Consolidated Edison Company of New York, Inc.
Indian Point Station
Broadway & Bleakley Avenue
Buchanan, NY 10511
Telephone (914) 734-5340
Fax: (914) 734-5718
blinda@coned.com

Re: Indian Point Unit No. 2
Docket No. 50-247
NL 01-092

SUBJECT: Indian Point 2 License Amendment Request for Reactor Coolant System Heatup and Cooldown Limitation Curves and Request for Exemption from the Requirements of 10CFR50.60(a) and Appendix G

Figure 3.1.A-1 PORV Open Pressure

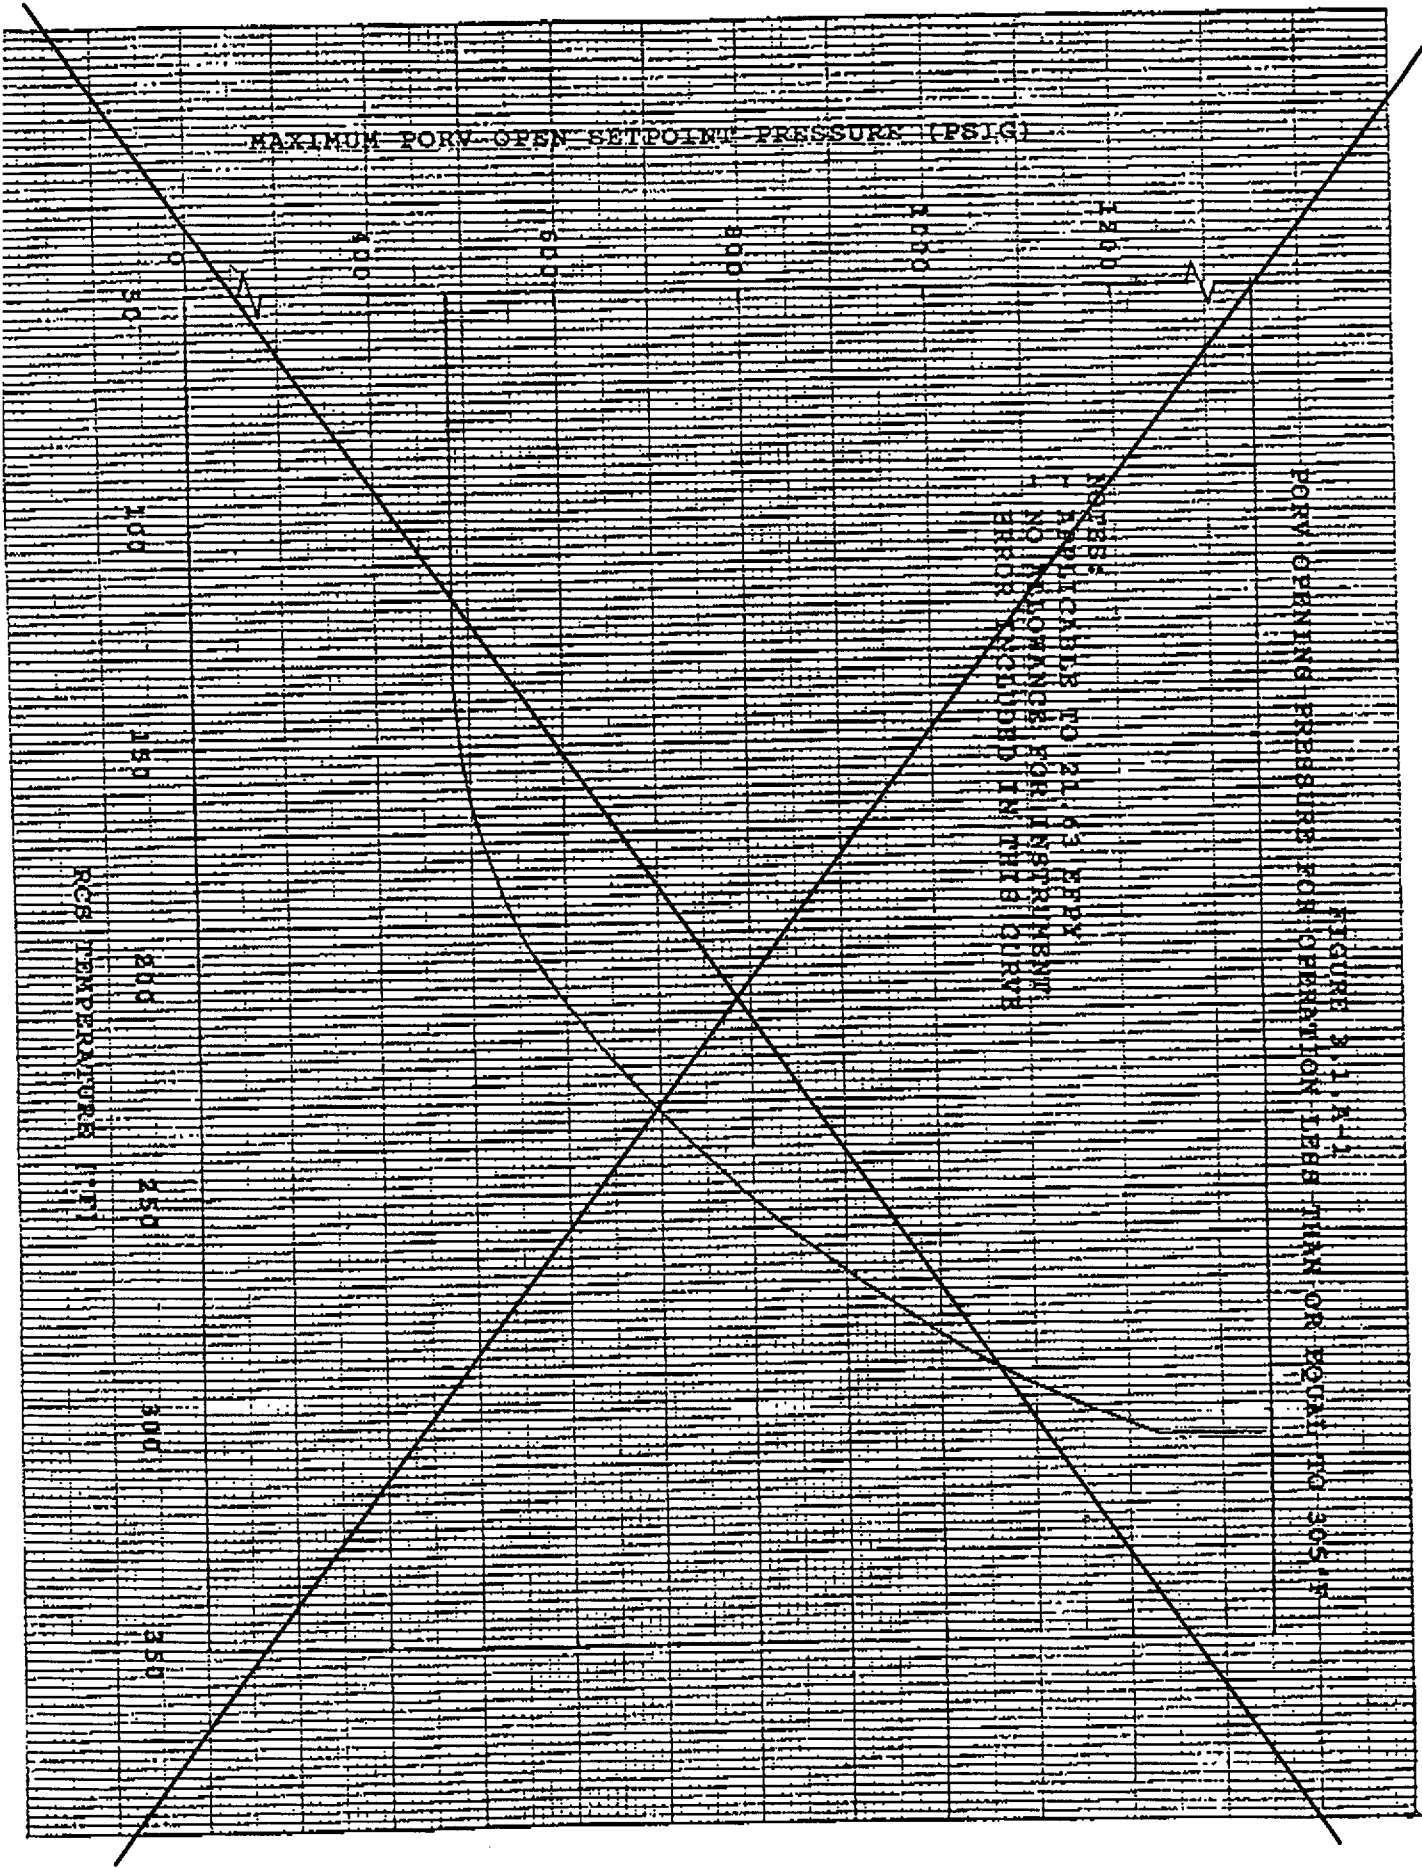
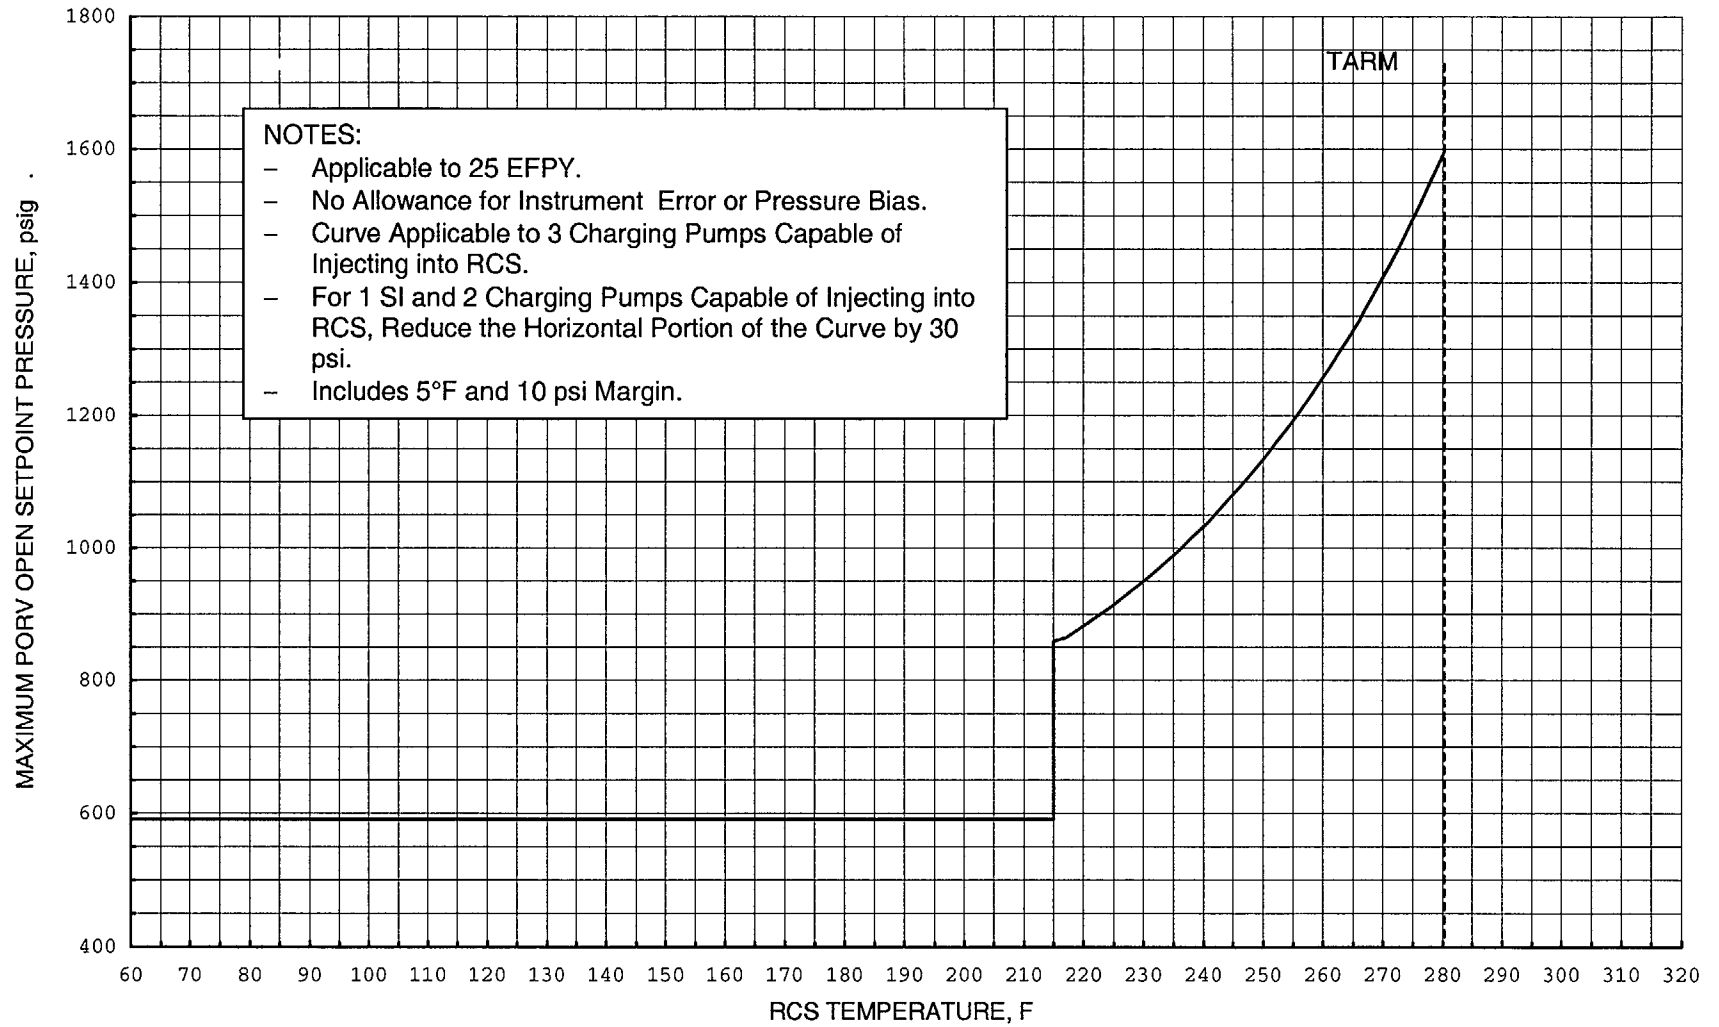
The analysis determined that a revised arming temperature of 280°F (reduced from a previous value of 305°F) along with the other proposed limits provides the required protection. By implementing the proposed OPS setpoints and limits, the OPS system will prevent the peak pressure from the analyzed events from exceeding the 10CFR50 Appendix G limits. Thus, the IP2 RPV continues to be protected against the analyzed overpressure transients through the 25 EFY analysis limit.

- a. Except as permitted by Table 3.1.A-2, the OPS shall be armed and operable when the RCS temperature is ≤ 305 ~~280~~°F. When OPS is required to be operable, the PORV will have settings within the limits shown in Figure 3.1.A-1.

Figure 3.1.A-2 Maximum RCS Pressure: OPS Inoperable and 1 Charging Pump Capable of Injecting into the RCS

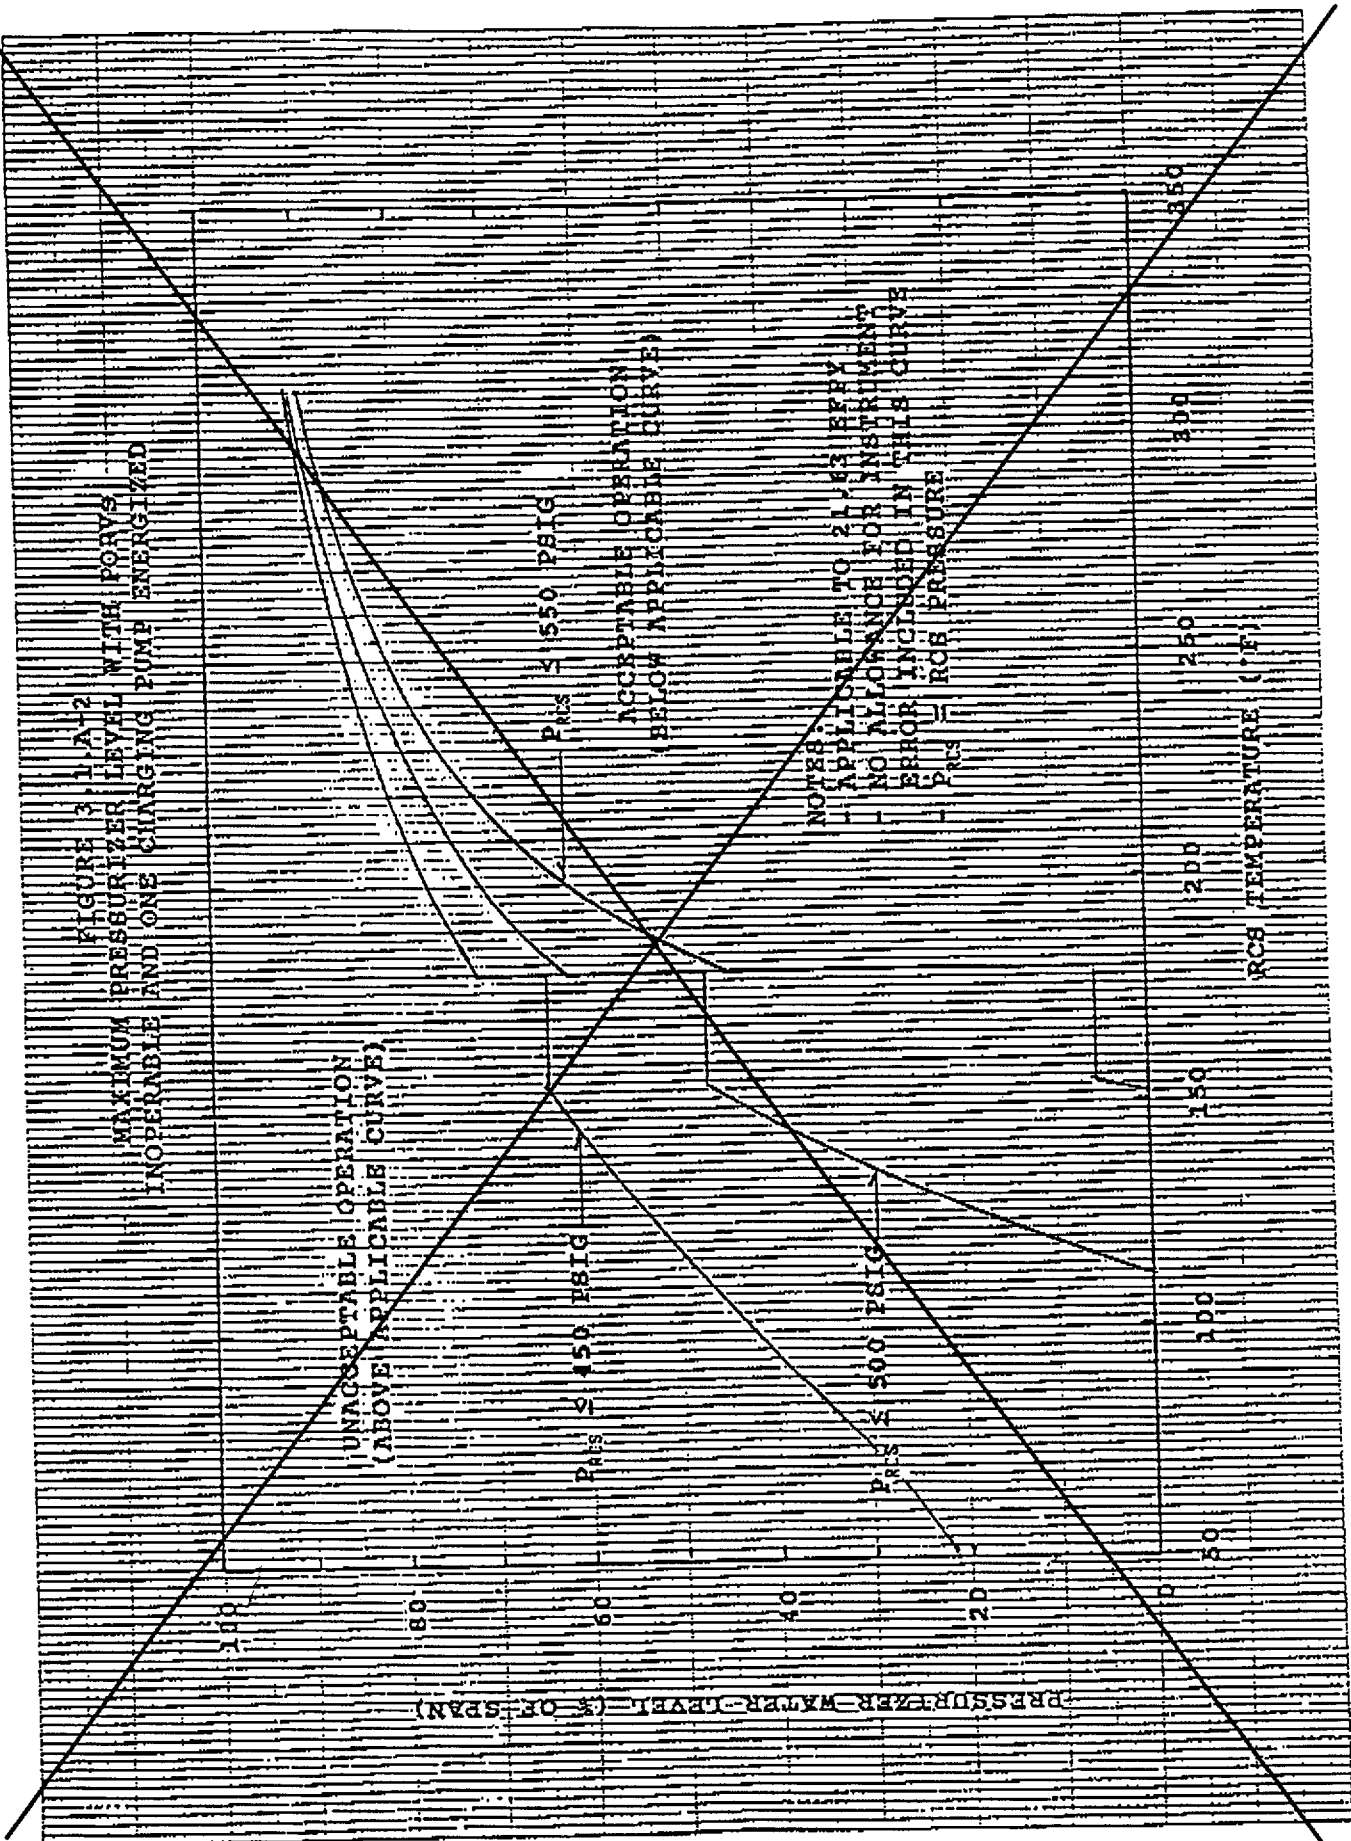
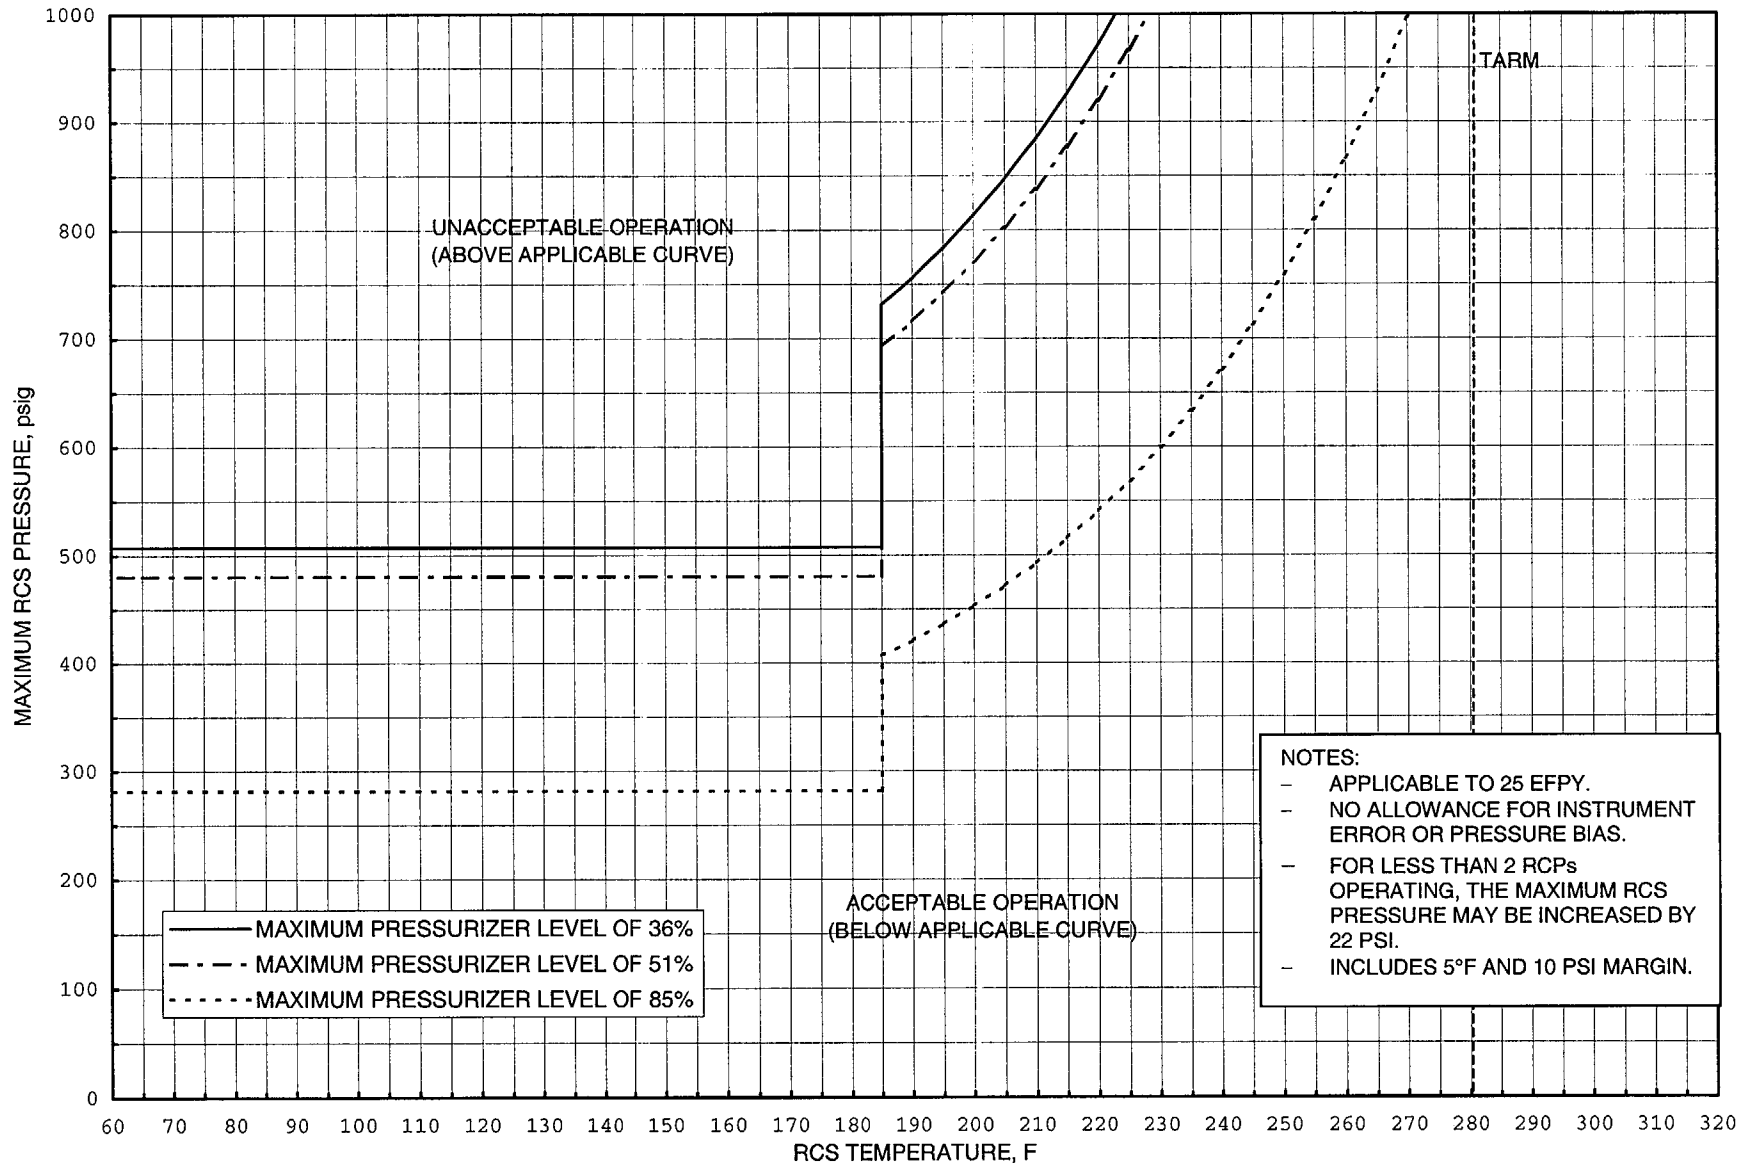
4. Table 3.1.A-2 OPS Operability Requirements
5. Figure 3.1.A-1 PORV Opening Pressure for Operation Less Than or Equal to 305°F
6. Figure 3.1.A-2 Maximum Pressurizer Level with PORVs Inoperable and One Charging Pump Energized
